DOCUMENT 00 90 00
ADDENDUM

ADDENDUM NO. [2] **Date: February 24, 2021**

RE: WESTERN TECHNICAL COLLEGE
SPARTA PUBLIC SAFETY EXPANSION
11177 COUNTY HWY A
SPARTA, WISCONSIN 54656
HSR PROJECT NO. 20028

This Addendum consists of [5] pages, [1] Revised Bid Form, [1] specification section [21] 30 x 42 drawings and [1] prior product approval.

P201

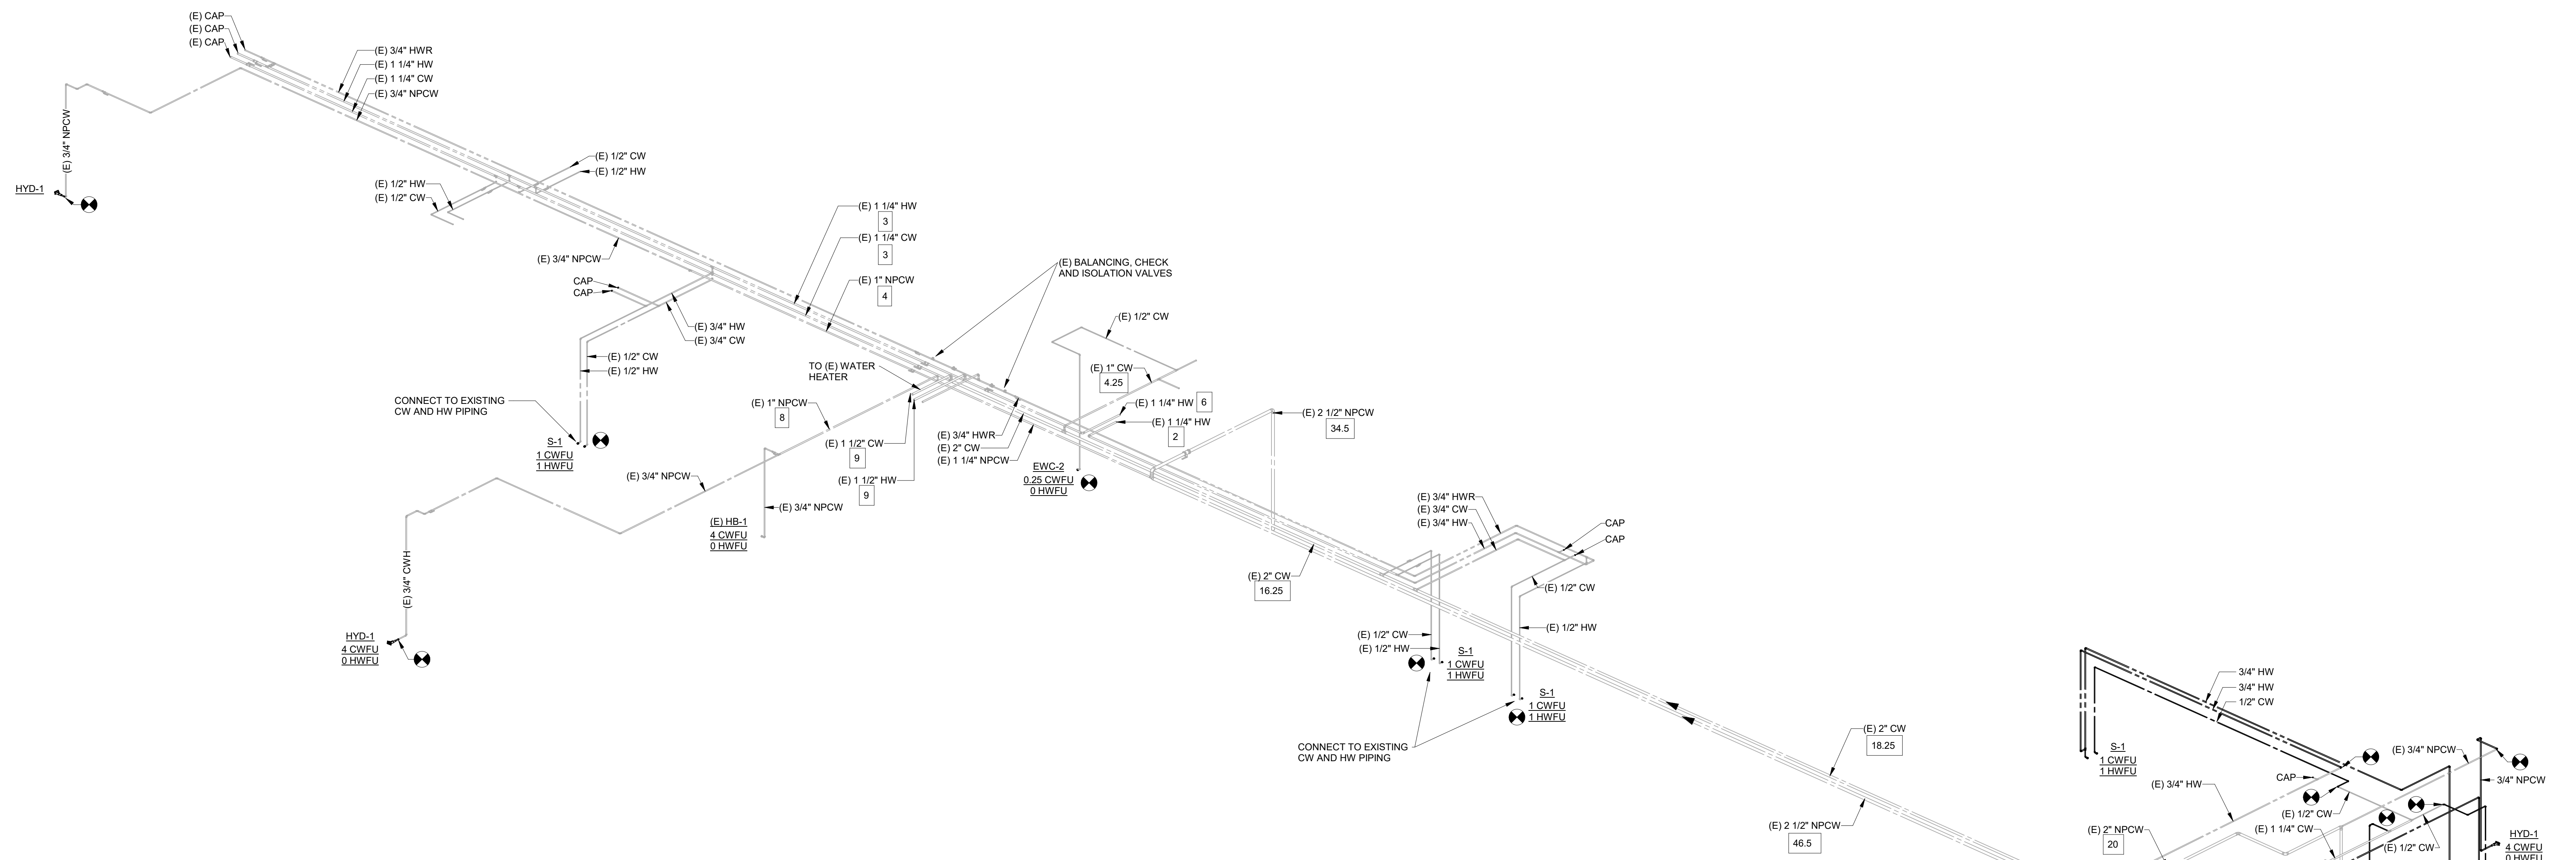
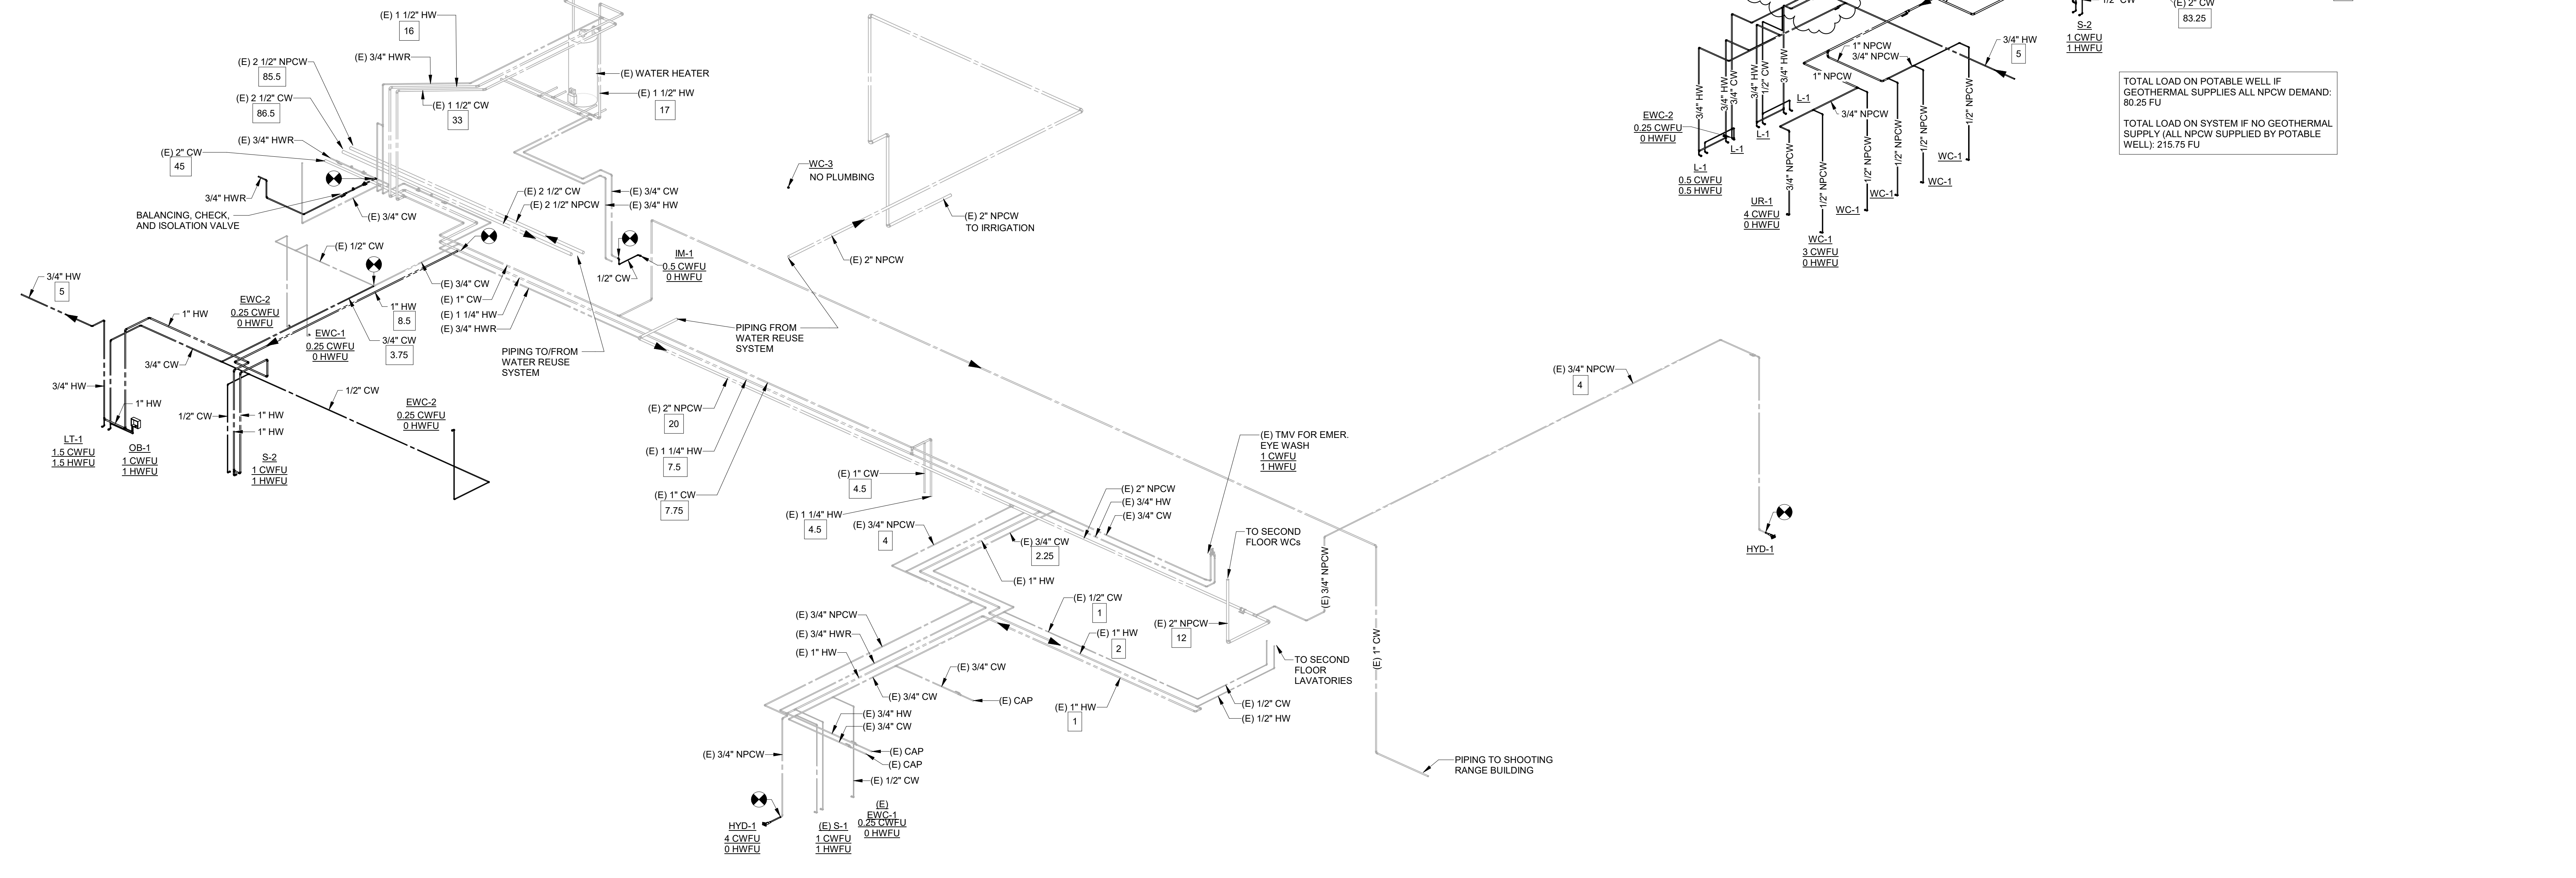
25. Sheet P201 WATER RISER DIAGRAM 30 x 42 attached hereto
 - a. Revisions clouded on Drawing
 - b. Bypass valves for hot water loop to lavatories in Women’s and Men’s bathroom.

1 FIRST FLOOR LIGHTING PLAN - AREA A
SCALE: 1/8" = 1'-0"
20-07-E-LP01

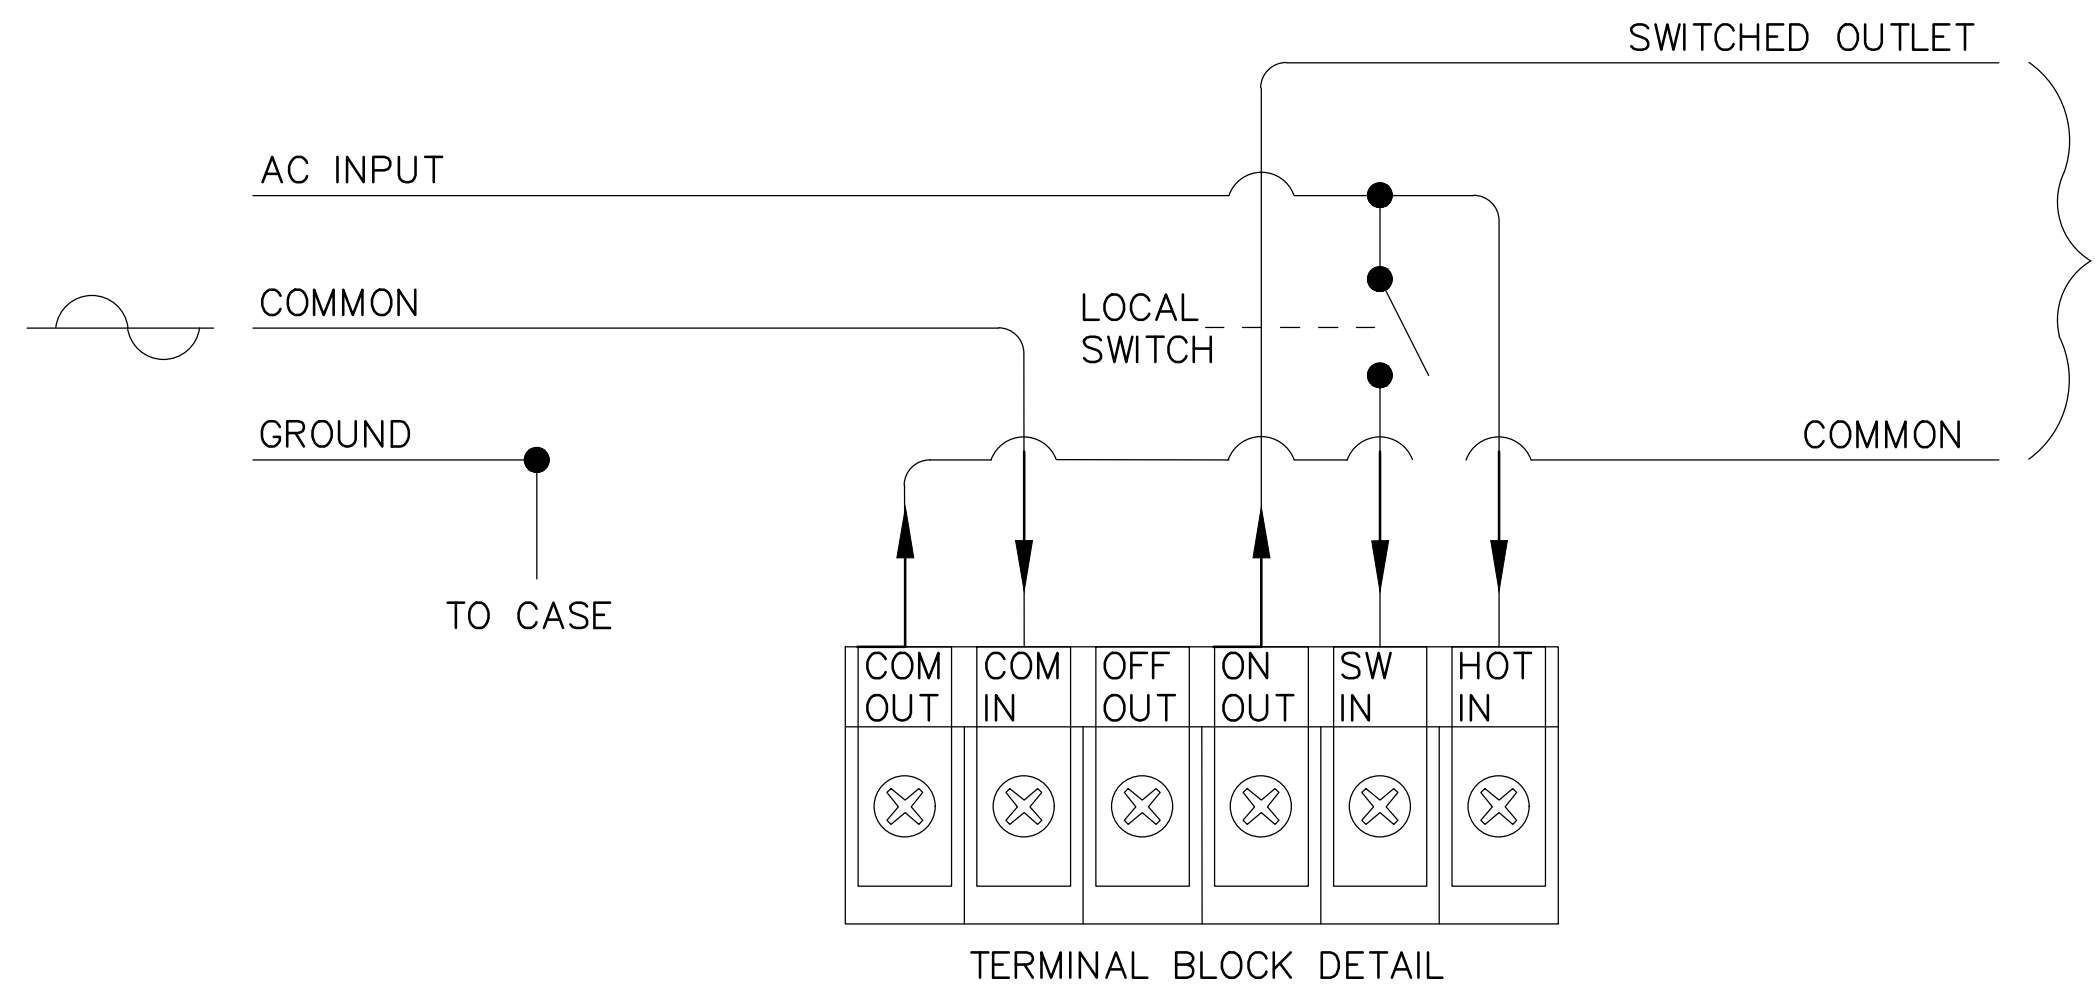
26. Sheet E101 FIRST FLOOR LIGHTING PLAN – AREA A 30 X 42 attached hereto
 - a. Revisions clouded on Drawing
 - b. In Kitchen #103; Empty keyed note symbol pointing at room number has been deleted and erased from the drawing.

- c. In IT Room #1TI; Empty keyed note symbol has been deleted and erased from the drawing.
 - d. In EMS Training #105; Make 120VAC connection to reinstalled existing Lighting Fixture provided by Owner located above Hill Rom Head Board, final connection shall match previous installation. Refer to Photo #1/E101. Coordinate mounting height with WTC EMS Instruction Department. Refer to Clouded Change dated 2-24-2021 with keyed note #52.

- e. Refer to General Note 'B' located at top of each lighting plan sheet. This note has been revised to allow 'Wattstopper Manufacturer' as an approved lighting control manufacturer for this project. Please note ONLY Acuity n-Light, and Wattstopper Lighting Control Manufacturers are allowed to bid this project.

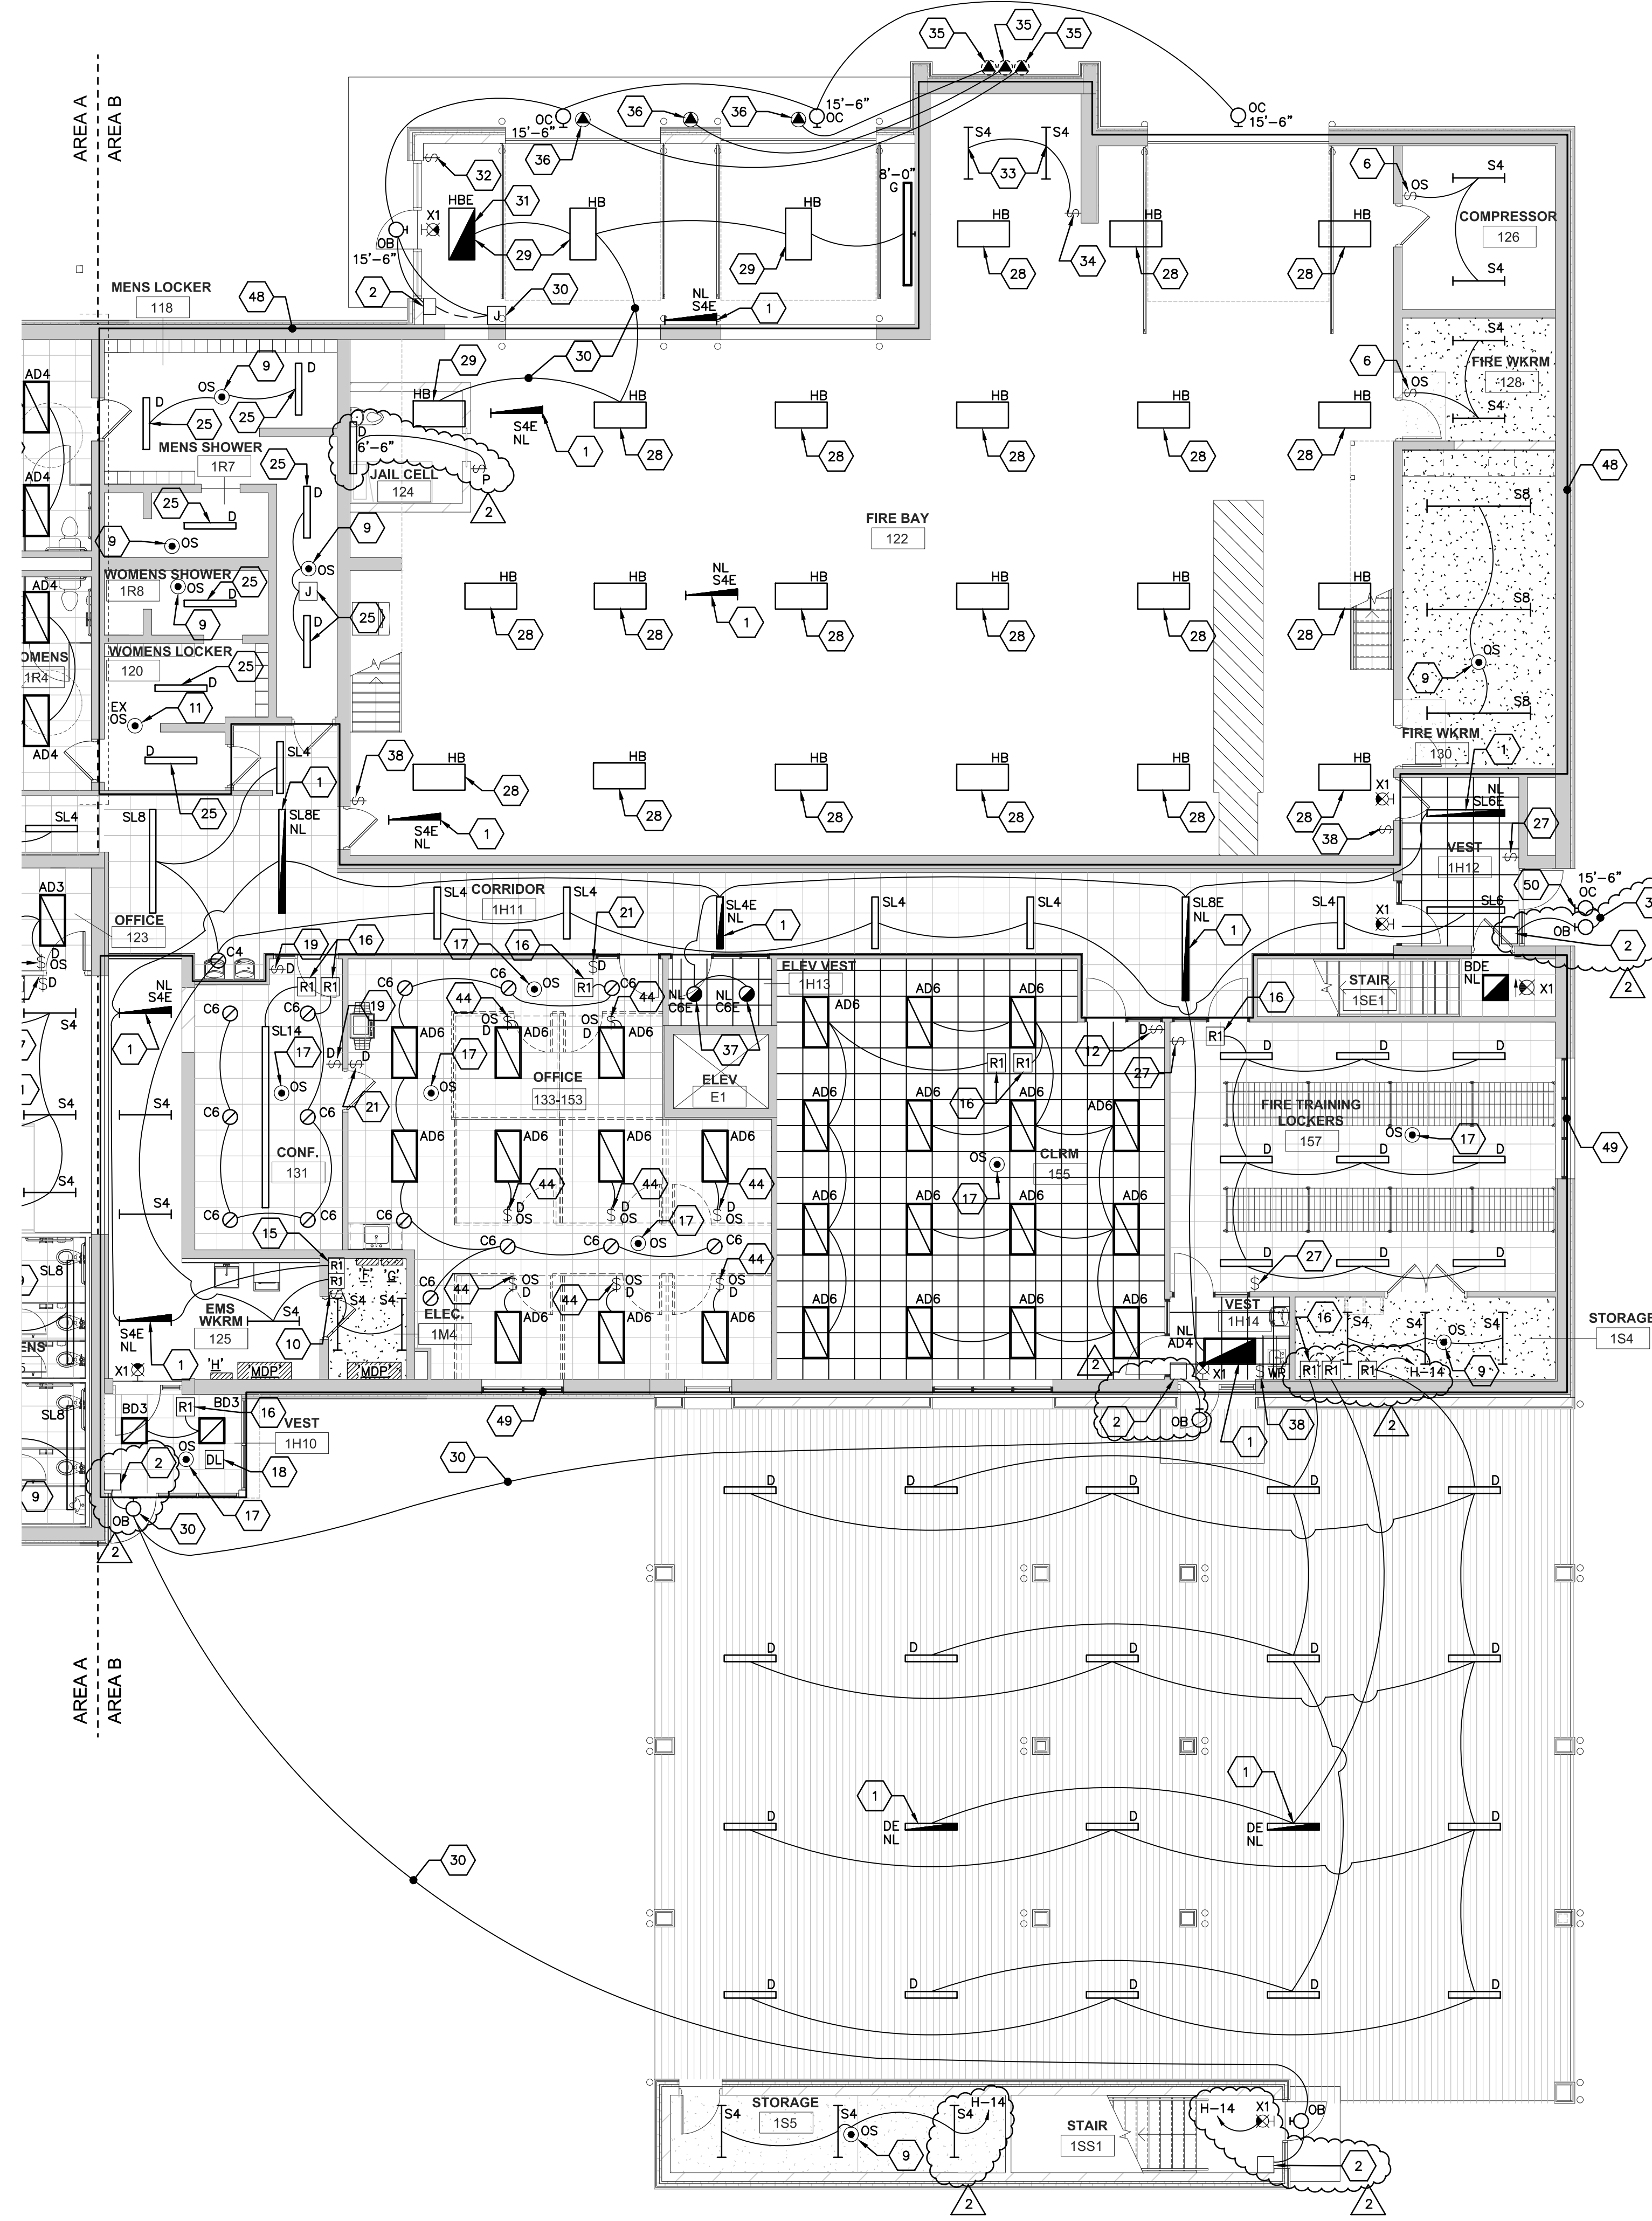
27. Sheet E102 FIRST FLOOR LIGHTING PLAN – AREA B 30 X 42 attached hereto

- a. Revisions clouded on Drawing
- b. In Vestibule 1H10; Provide a mini inverter and connect to exterior type 'OB' wall pack. Refer to clouded change with keyed note #2 dated 2-24-2021.
- c. In Vestibule 1H12; Provide a mini inverter and connect to exterior type 'OB' wall pack. Provide One (1) type 'OB' exterior wall sconce lighting fixture. Refer to clouded change with keyed note #2 dated 2-24-2021.
- d. In Vestibule 1H14; Provide a mini inverter and connect to exterior type 'OB' wall pack. Refer to clouded change with keyed note #2 dated 2-24-2021
- e. In Stair 1SS1; Provide a mini inverter and connect to exterior type 'OB' wall pack. Refer to clouded change with keyed note #2 dated 2-24-2021.
- f. Refer to Jail Cell #124; Provide One (1) type 'D' lighting fixture and One (1) single-pole light switch with a red pilot light. Refer to clouded change dated 2-24-2021.
